Transportation Study of the U.S. Route 1 College Park Corridor

Final Report

July 14, 2008

Figure 43: Erie Street to Indian Lane

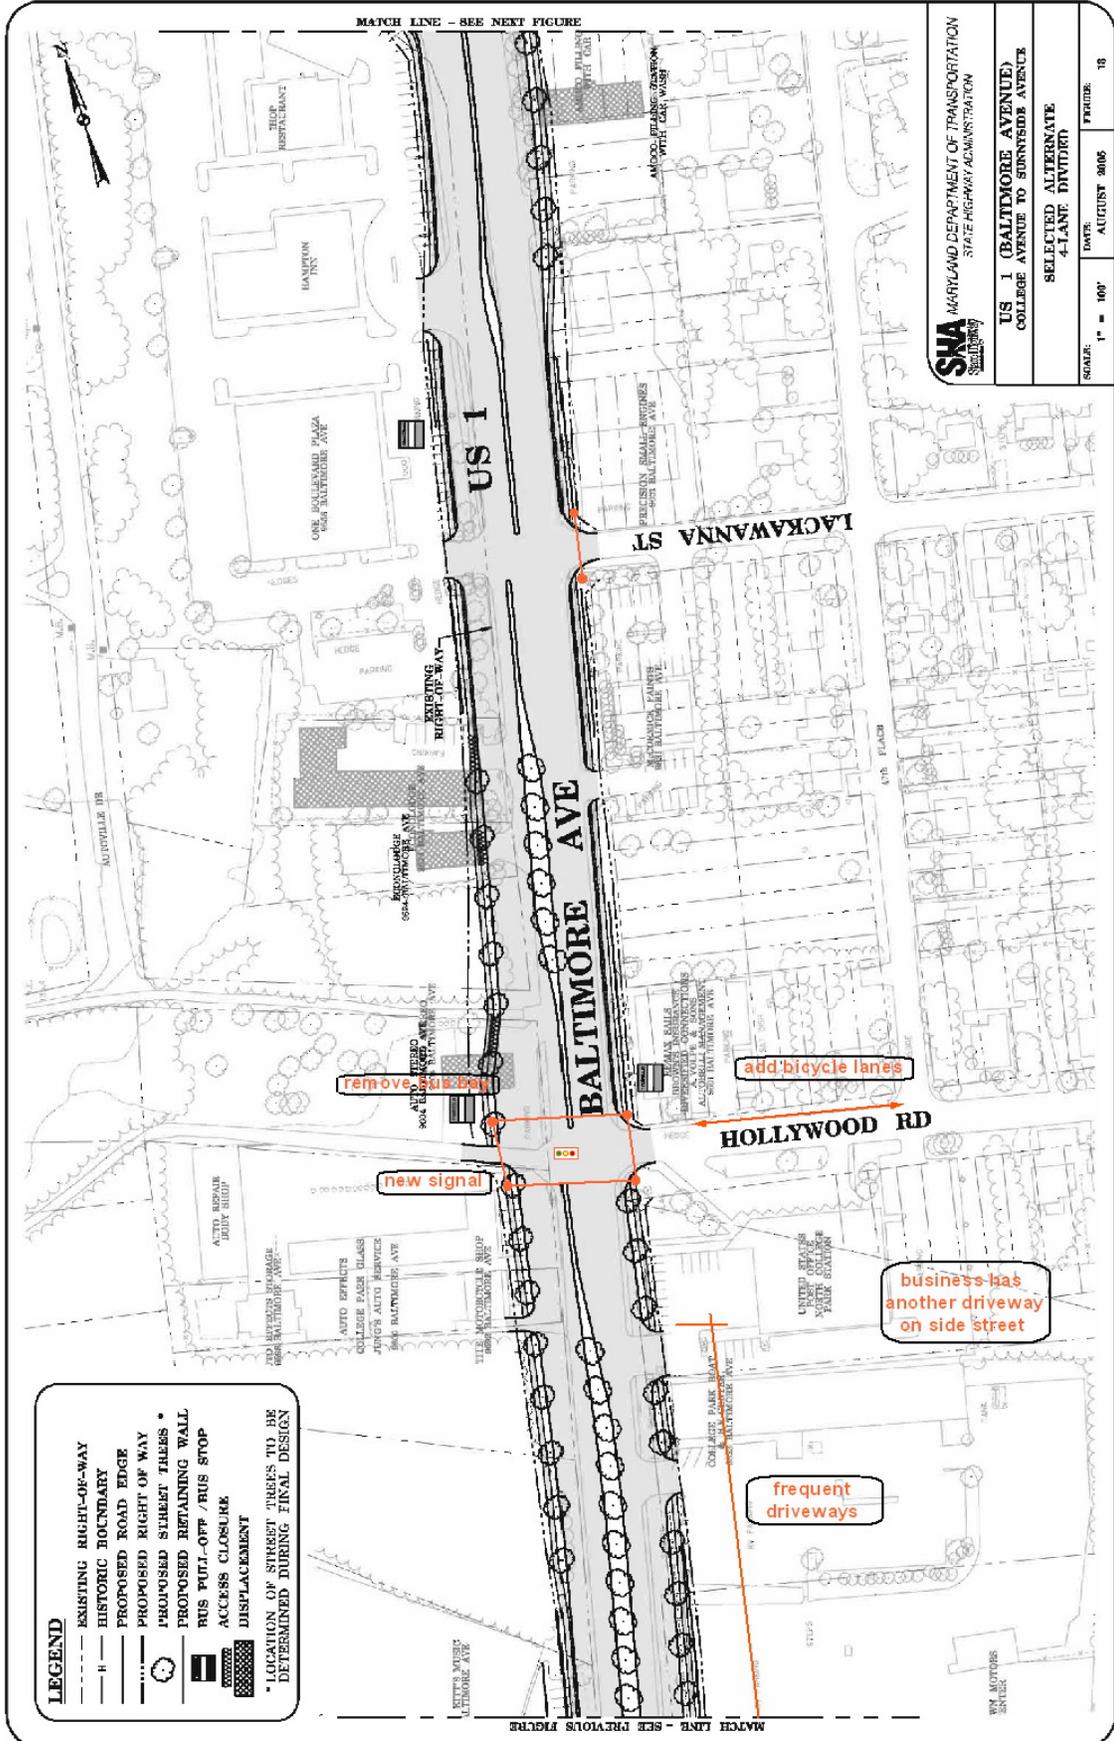
Figures 41 to 49 on the following pages provide annotations to the road design proposed in SHA's *Finding of No Significant Impact*, based on the comments made throughout this report.
